**INFORMATION REQUEST**  
**(Given under Section 12 of the Development Assessment Rules)**

**Street Address:** 42-52 Mitre Street CRAIGLIE  
**Real Property Description:** LOT: 900 SP: 342106  
**Local Government Area:** Douglas Shire Council

**Application Number:** OP 2024\_5589/1  
**Approval Sought:** Development Permit  
**Nature of Development Proposed:** Operational Works  
**Description of the Development Proposed:** Operational Works (Works associated with housing development)

Figure 1(a) Neon Drawing 501 (Sewerage Plan)

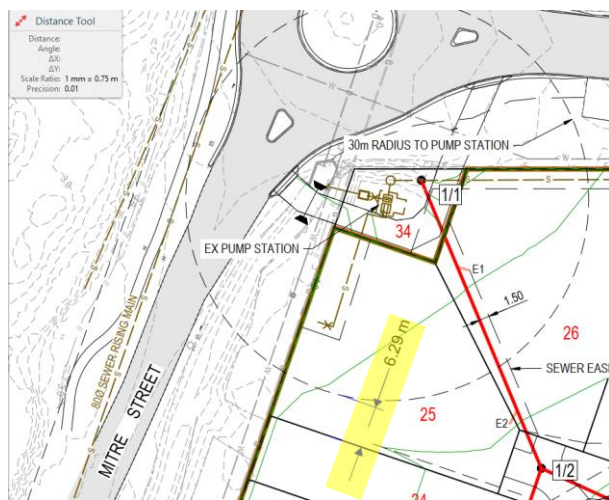
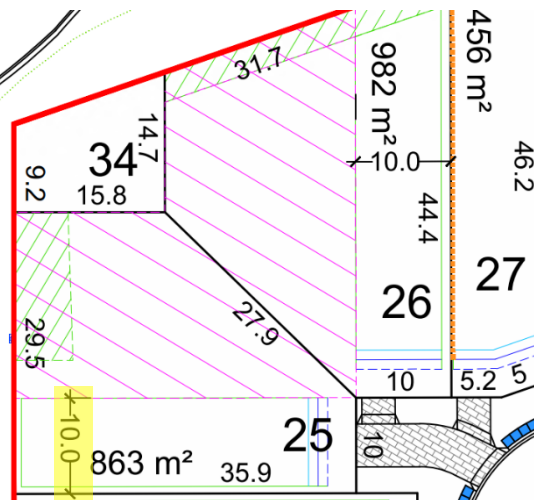
8. Clarify how the total width of Lot 25 (excluding the SPS easement area) is sufficient to enable construction of the dwelling proposed for this allotment.

The dwelling concepts nominated in the preceding Combined Application submission (DSC Ref: CA 2023\_5488/1) indicates a 10m width is required for Lot 25.

**Advice Note:** Officers note the width between the 30m SPS exclusion radius and the shared boundary with Lot 24 appears to be approximately 6.3m. The Plan of Development by RPS dated 21 July 2023 (Plan Ref: AU6631 – 07a) indicates the width of Lot 25 is 10m to accommodate the dwellings proposed by Allaro Homes. Refer to figure 1a and 1b below.

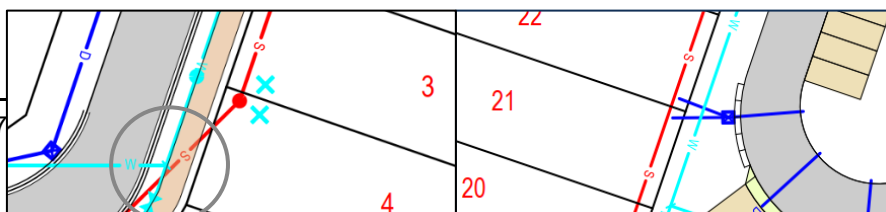
10. The Applicant is requested to assess services crossing the proposed internal water mains and potential implications to thrust block stability if future maintenance of services (i.e. services trenches) is required. In particular, the assessment must address the level of risk associated with how maintenance of sewer mains crossing below water main thrust blocks may impact the stability of these thrust blocks.

**Advice Note:** Officers note two instances where there is potential for water main thrust blocks to become undermined if maintenance of the underlying sewer mains is required in future works. Refer to figure 2 below.

Figure 3. Non-Standard Water Main Pipe Bend

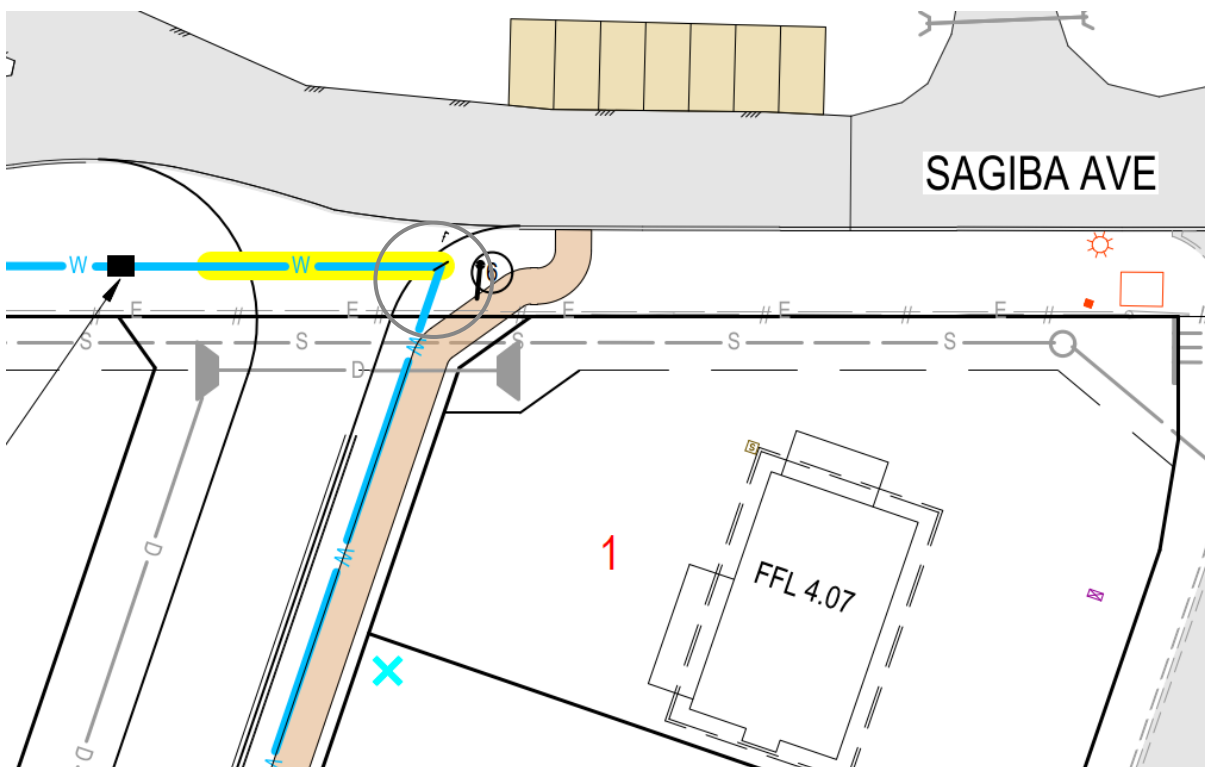
11. Confirm the intended construction details and fittings for the water main pipe bend proposed in Sagiba Avenue at the frontage to the development.

*Advice Note: Officers note the proposed pipe bend shown in the figure below is greater than 90 degrees and seeks advice of the combination of fitting alignment for consideration. Refer to Figure 3 below.*
